# CITY OF ALBUQUERQUE

RE: Lot 7 Block 8 Unit 5 SAD 227 6201VKayenta Dr. NW Grading and Drainage Plan Engineers Stamp Date 1/25/19 (E10D051) Pad Certification Date 3/4/20

### DRAINAGE AND TRANSPORTATION INFORMATION SHEET (REV 6/2018)

DRAWN BY WCWJ 1-25-19 GRADING AND DRAINAGE PLAN 218144-LAYOUT-10-02-18 SHEET # Rio Grande \_\_\_

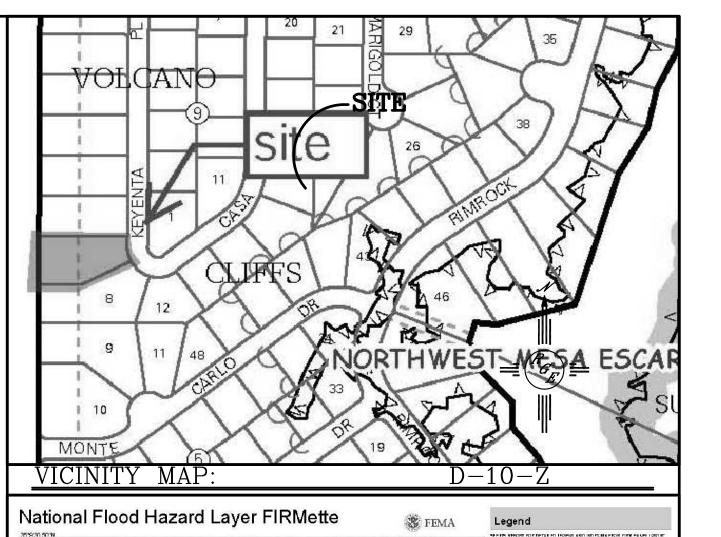
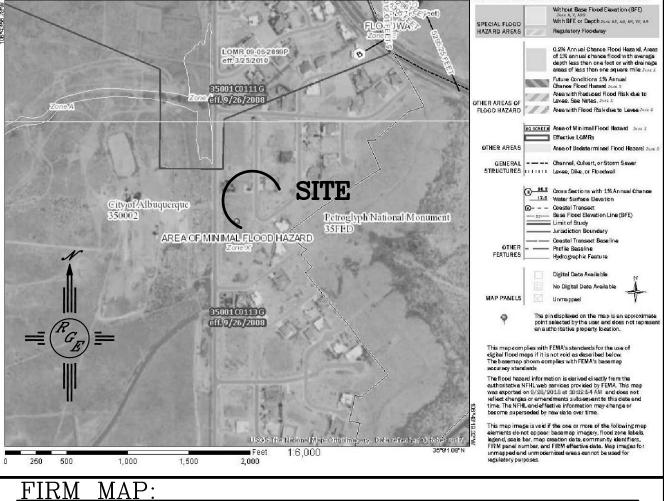
Based upon the information provided in your submittal received 3/4/20, this plan is approved for Building Permit.

Reiterate to the Owner/Contractor that a separate permit for a garden/retaining wall must be obtained, with the approved G&D plan dated 3/4/20.

Prior to Certificate of Occupancy release, Engineer Certification per the DPM checklist of this plan will be required.
